STATE OF NORTH CAROLINA  
DEPARTMENT OF TRANSPORTATION

Contract No.: DL00208  
WBS No.: DF16012.2023801  
TIP No.: None  
F.A. No.: None  
County: Cleveland  
Description: Replacing Bridge # 72 on SR 2226  
Let Date: April 13, 2021

**RE: Addendum #1 to Contract DL00208.**

NO.		REVISED		SHEET NO.	
BY:	DATE:	NO.	DATE:		
1		3		S-03	
2		4		SHEETS	20

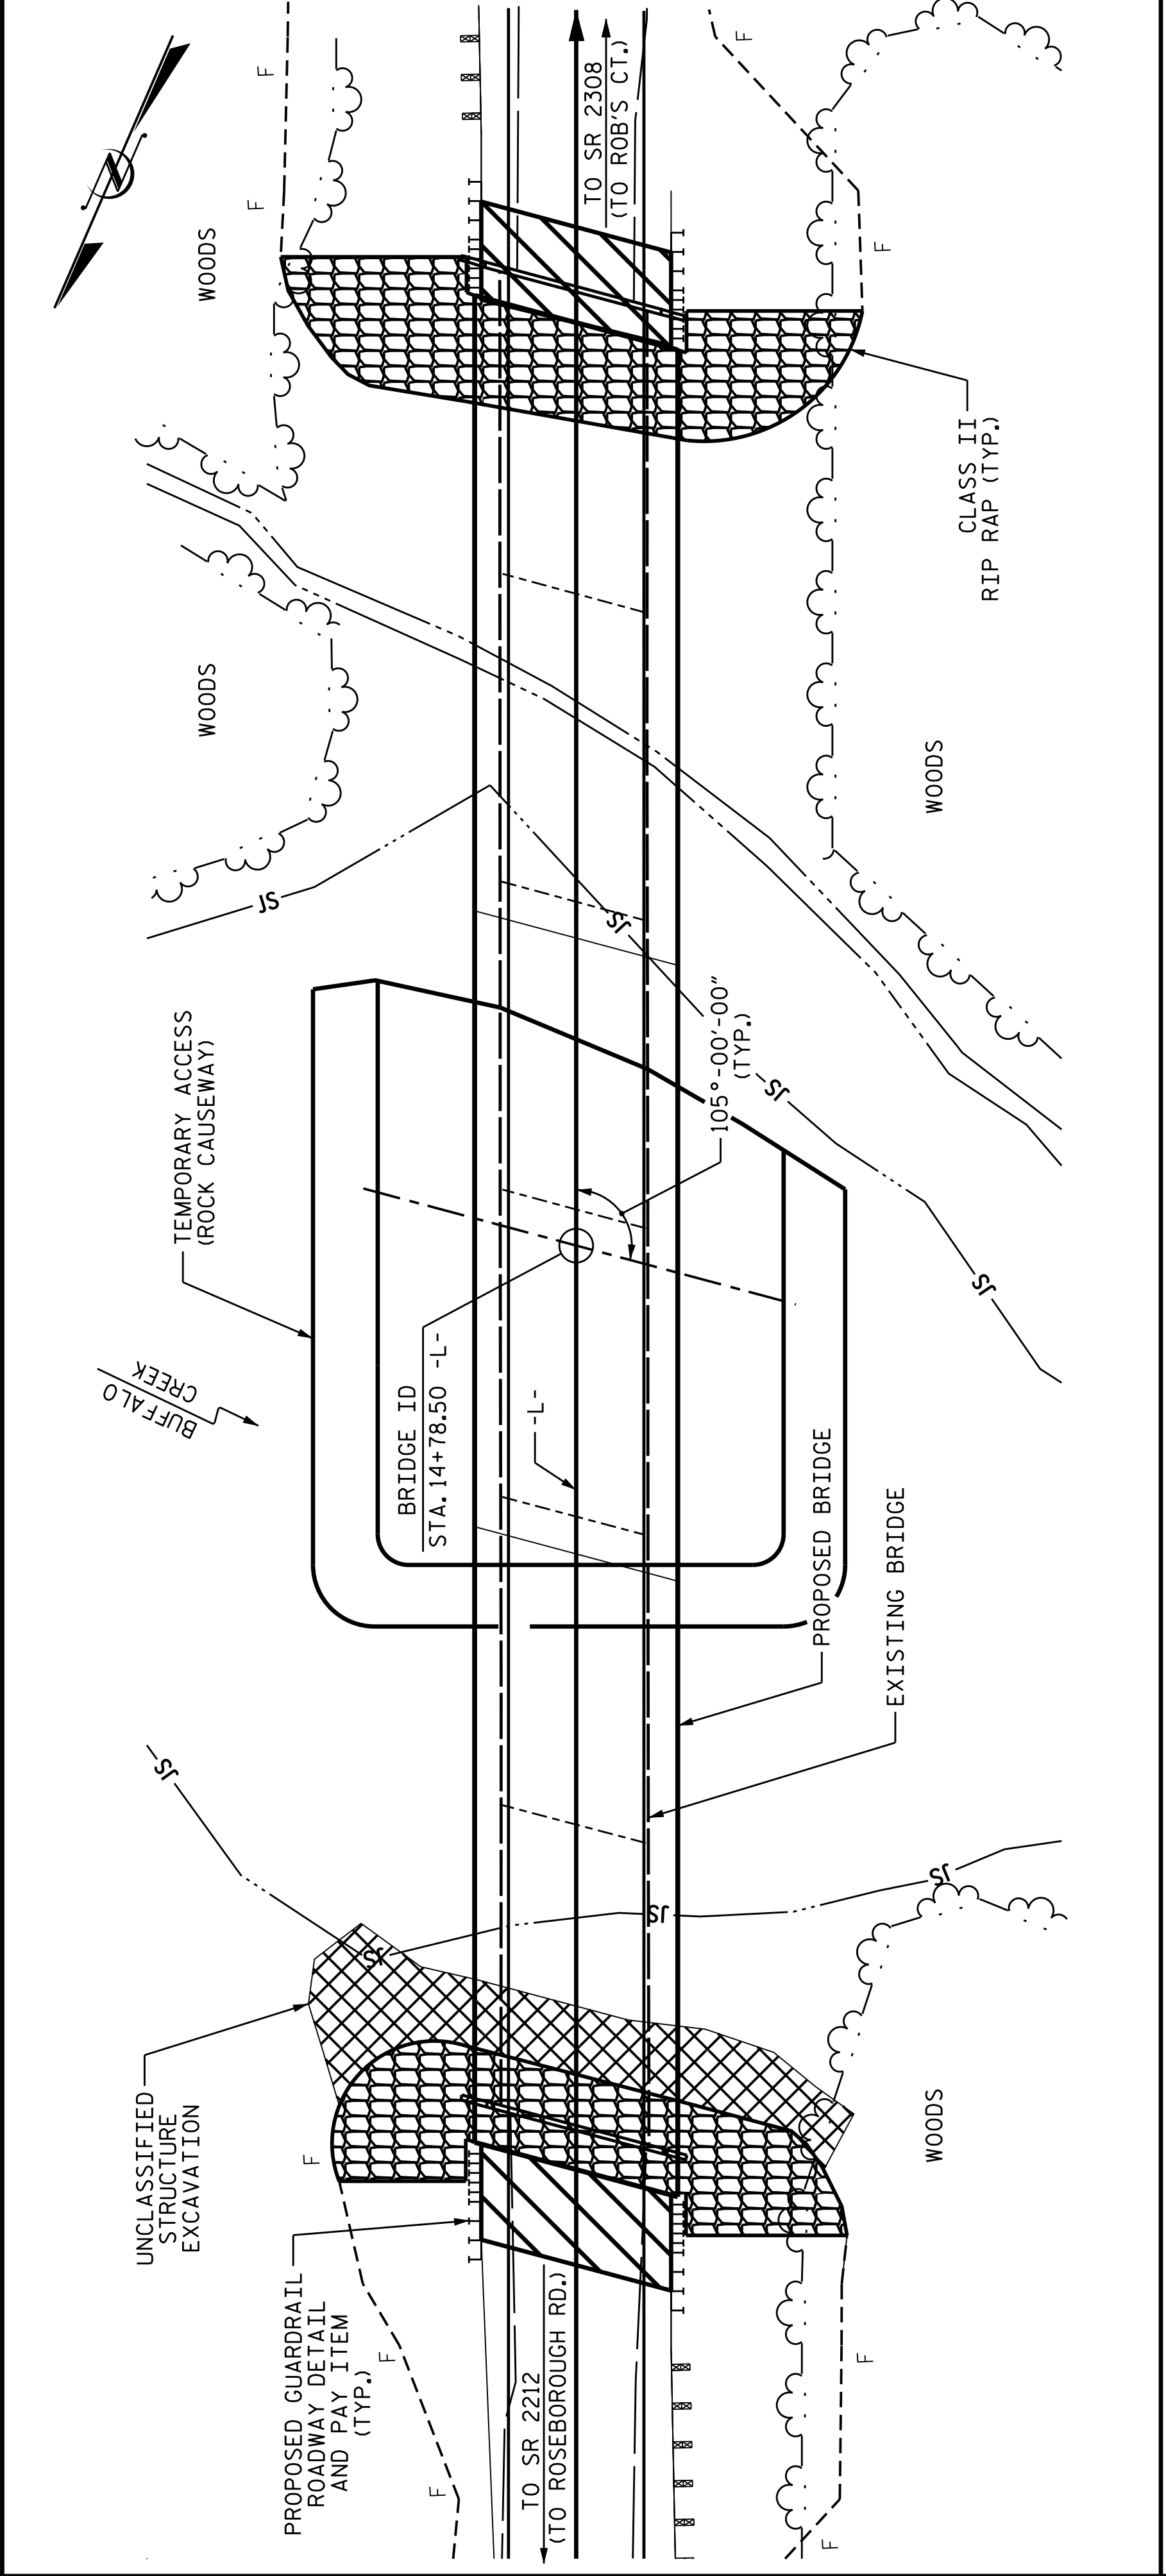
- Structure Plan Sheet S-03 has been revised.
- The quantity for bid item no. 78 – Vertical Concrete Barrier Rail has been increased from 200 linear feet to 600 linear feet.
